Evaluation of proposed move for Water Right No 3386

Proposed: Move 284.3 AF at 100 gpm from water right no. 3386 to a new well located 2,504 ft to the southwest. The current well location will retain more authority than is currently being used, so only the effect from pumping at the new well location was evaluated.

WELL TEST ANALYSIS

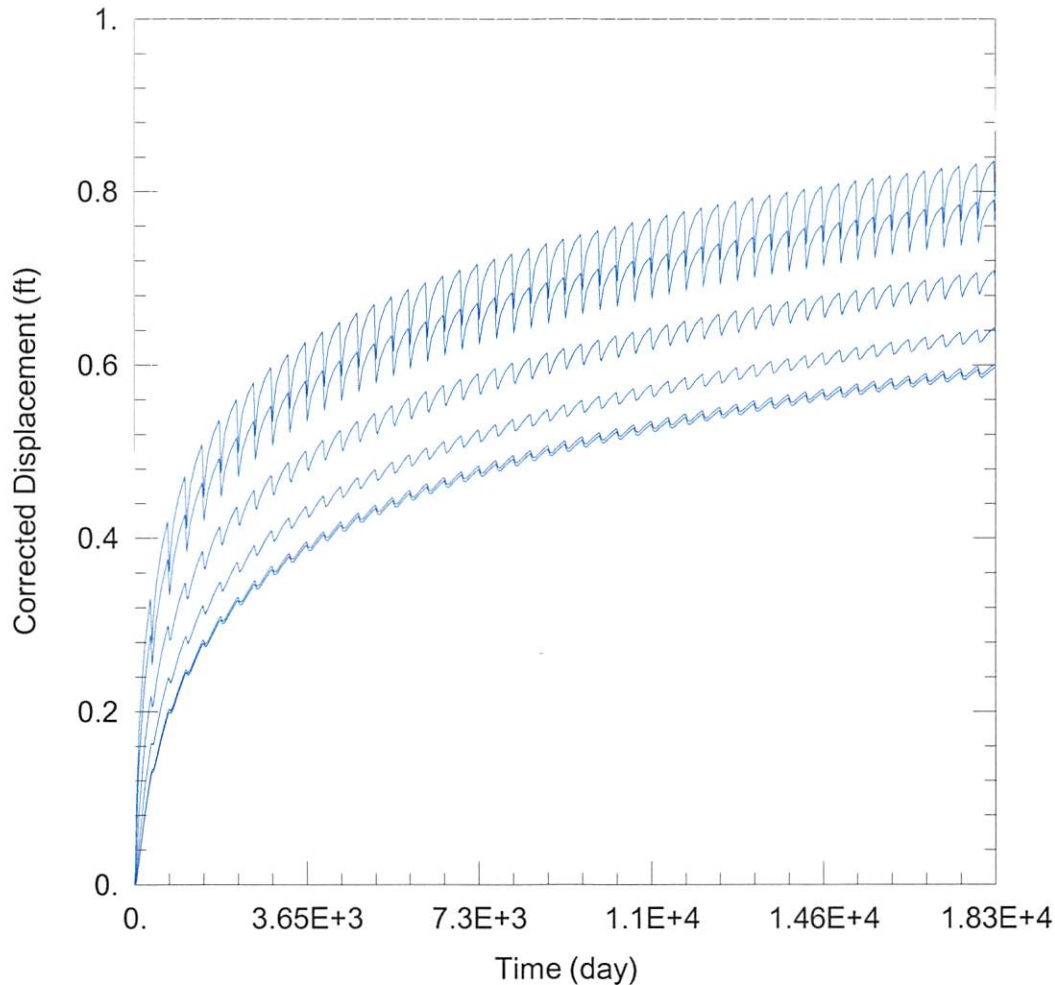
8678:	Net drawdown = **0.8 ft**
23954:	Net drawdown = **0.7 ft**
27633:	Net drawdown = **0.6 ft**
28112:	Net drawdown = **0.6 ft**
14489:	Net drawdown = **0.6 ft**
Domestic 22-27-33:	Net drawdown = **0.8 ft**

Net drawdown does not exceed the drawdown allowance of 4.0 ft for any wells within 1 mile of the proposed location. Therefore, critical well analysis is not necessary.

Based upon information from the GMD3 model, this proposal will cause minimal effects on neighboring wells, and is unlikely to create an impairment. GMD3 staff recommends approval of the application.
